Subject: Duke Energy Corporation  
Oconee Nuclear Station - Units 1, 2, and 3  
Docket Nos. 50-269, 50-270, and 50-287

Revisions to Topical Report DPC-NE-3003 In Support of  
Steam Generator Replacement  
Response to NRC Staff Request for Additional  
Information

Enclosed herein, please find the Duke Energy Corporation (Duke) response to the May 12, 2003 NRC staff's request for additional information concerning topical report DPC-NE-3003, Revision 1, "Mass and Energy Release and Containment Response Methodology."

### **Duke Power Response To Request For Additional Information**

**GOTHIC 7.0 - FATHOMS COMPARISON**  
**ROTSG LARGE BREAK LOCA**  
**(8.55 ft<sup>2</sup> Break - Cold Leg Pump Suction)**

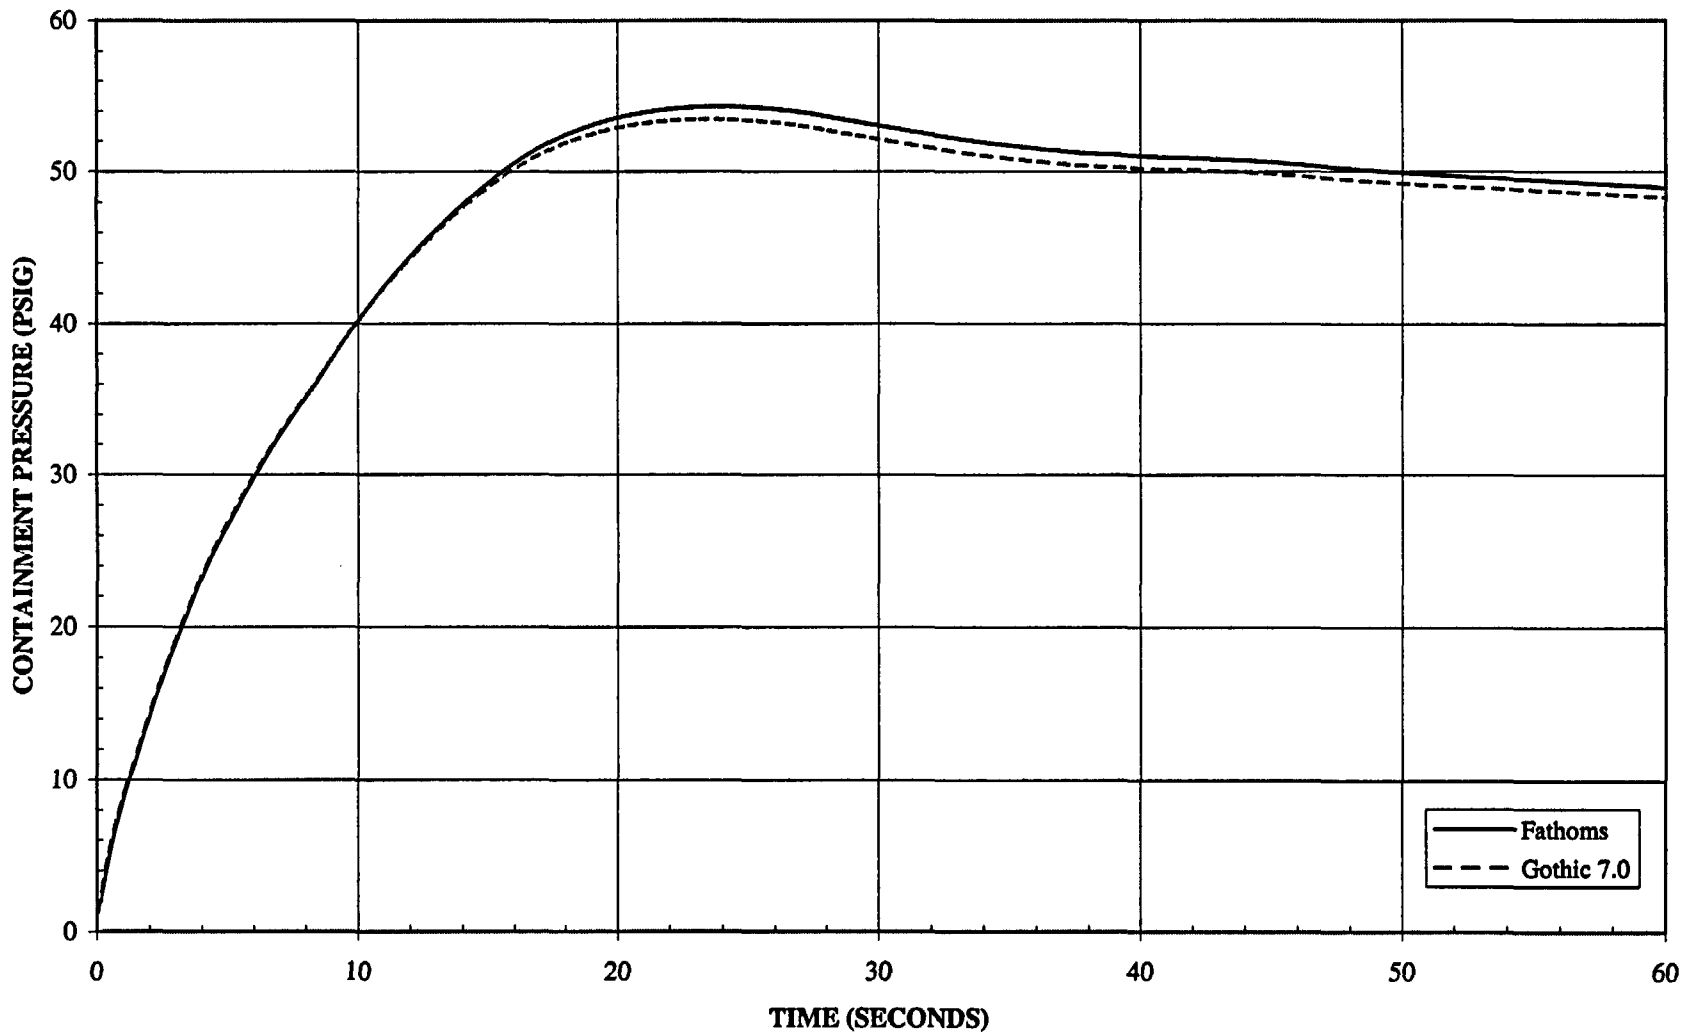
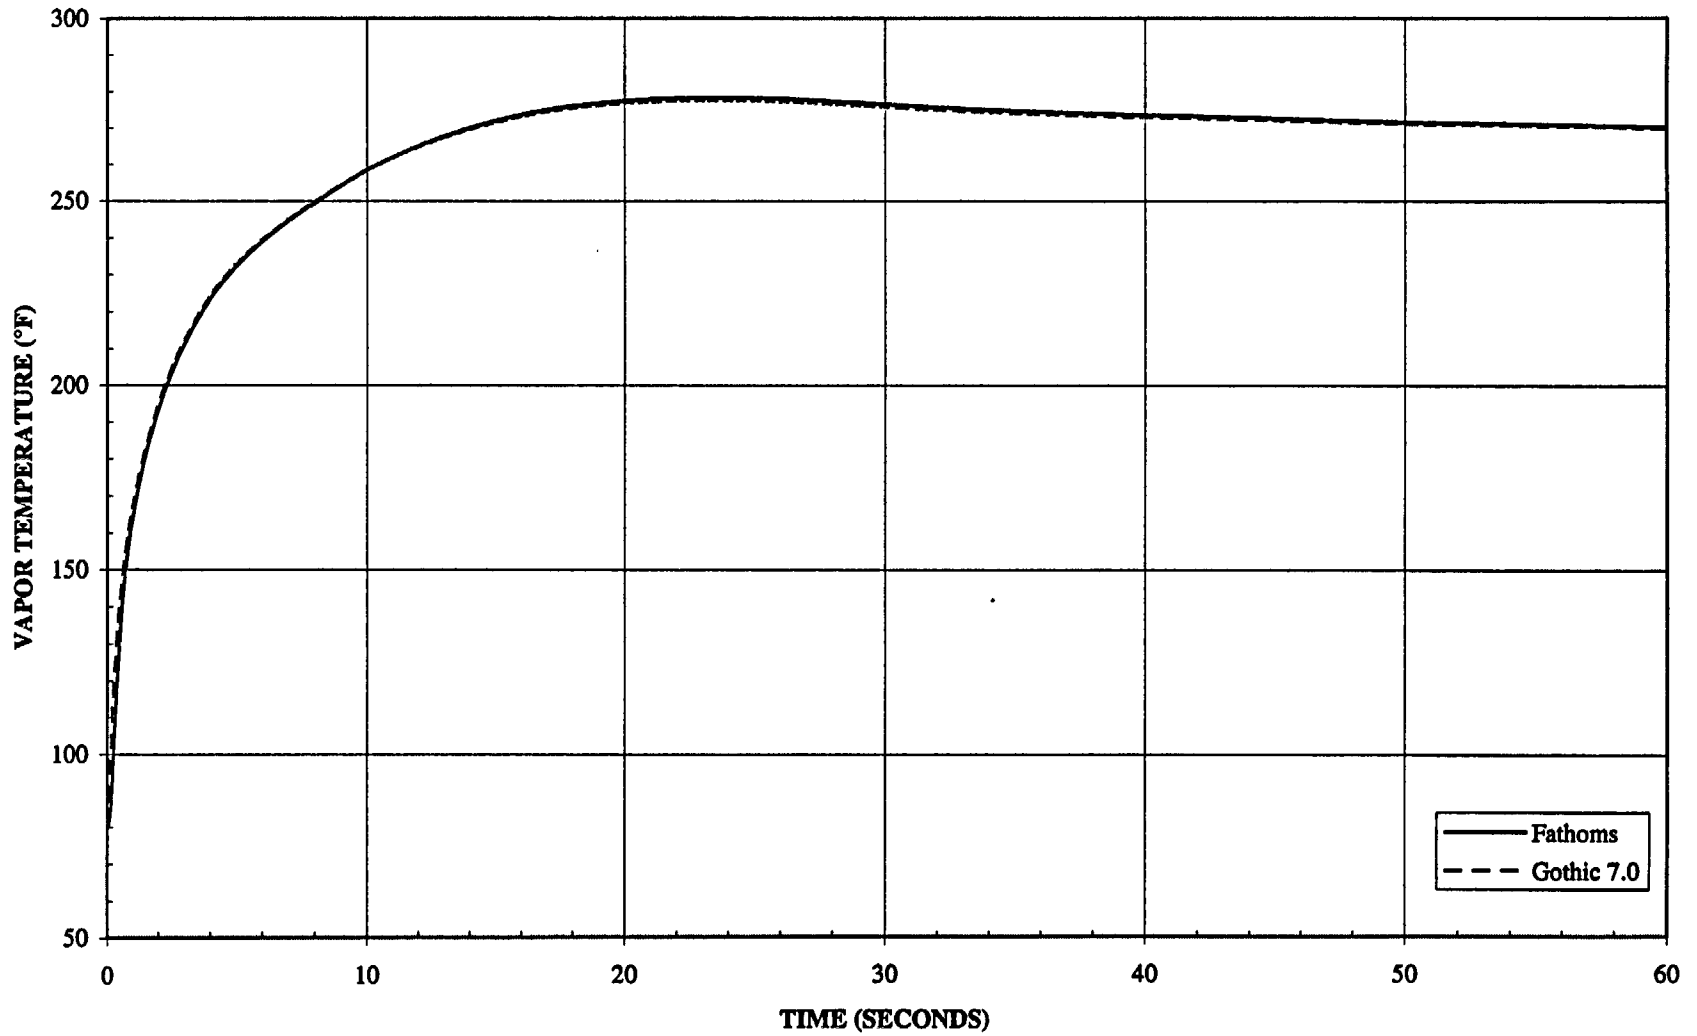
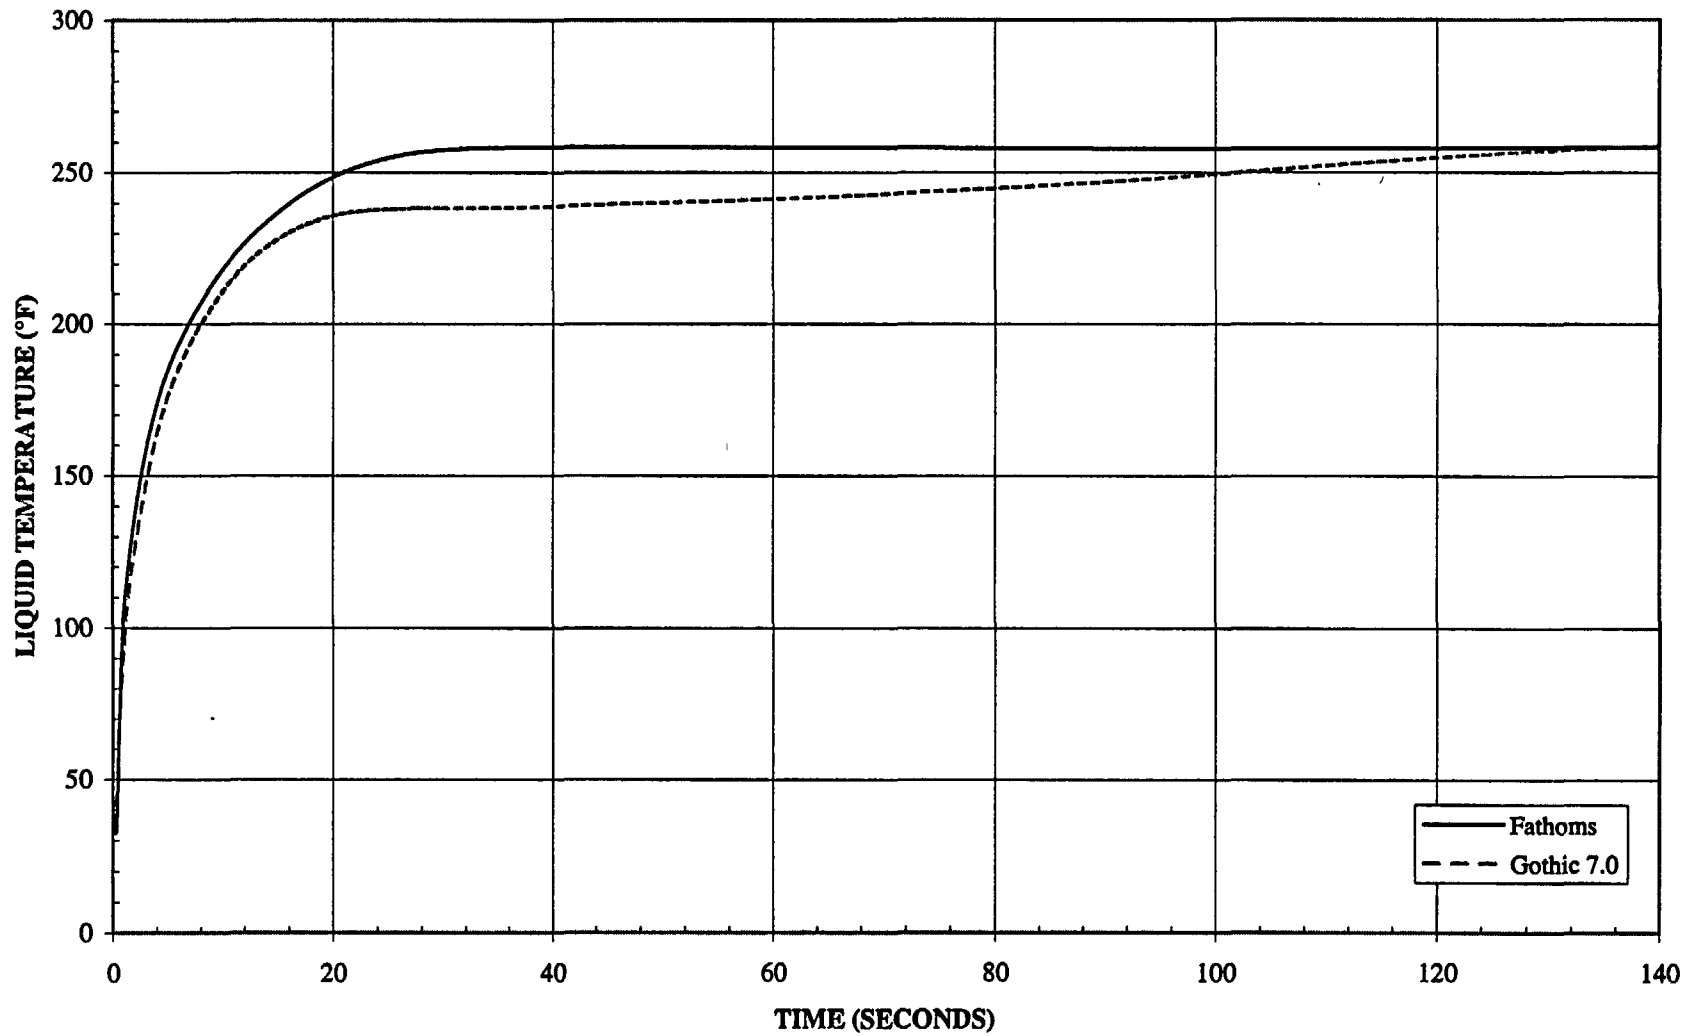
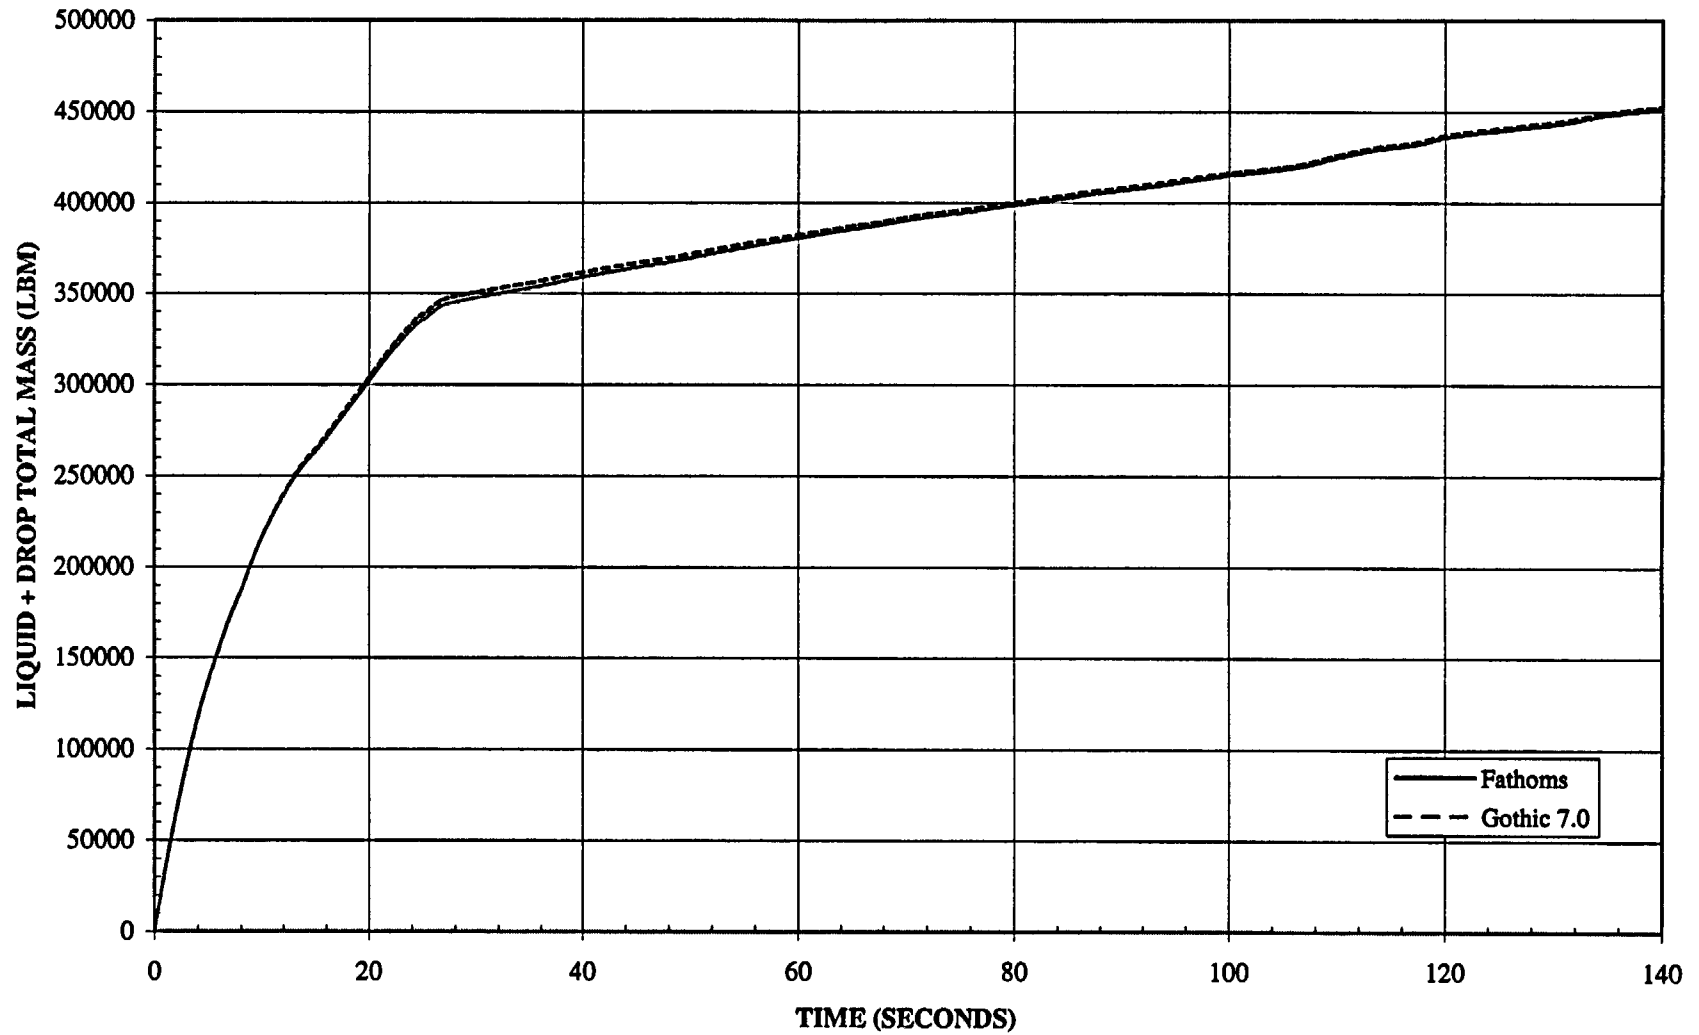
3. Please provide the results using the GOTHIC 7.0 code of peak pressure and temperature calculations for the sensitivity cases listed in Table 3.1-1 of DPC-NE-3003 in tabular and graphical form. If the results or conclusions are significantly different from those presented in DPC-NE-3003P, explain the difference.

Response: Table 3.1-1 of DPC-NE-3003 describes a spectrum of LOCA peak pressure cases including a range of break locations and sensitivity analyses for several important modeling assumptions. The staff's request is understood to focus on the difference in the predicted results from the FATHOMS and GOTHIC 7.0 code versions. Rather than show the comparison for the cases in Table 3.1-1, a different set of cases has been selected which is more focused on the current knowledge of the key sensitivity parameters. Also, the results presented are for the ROTSGs, which is the subject of Revision 1 to the topical report.

The results of the 14 code comparison analyses are shown in Table 3-1 below and in the figures that follow. In general, the pressure and vapor temperature response predictions were very similar in both magnitude and trend. GOTHIC 7.0 predictions for peak pressures and vapor temperature were slightly lower (~0.5 psig and 0.5°F). These differences are consistent with the code model differences described in the response to Question #1. Both codes predict a saturated containment atmosphere due to the large amount of drops injected. The slightly lower pressure, vapor temperature, and liquid temperature from GOTHIC 7.0 may be attributed to additional drop hold up in the atmosphere. This effectively increases the heat capacity of the atmosphere and reduces the temperature rise for a given energy addition. A comparison of the total liquid and drop masses, and liquid temperatures, show the predictions of the two codes to be essentially the same. This is consistent with the changes in the drop deposition and entrainment models discussed in Question #1. These results show that the two code versions give essentially similar results for the same break location and initial and boundary conditions.
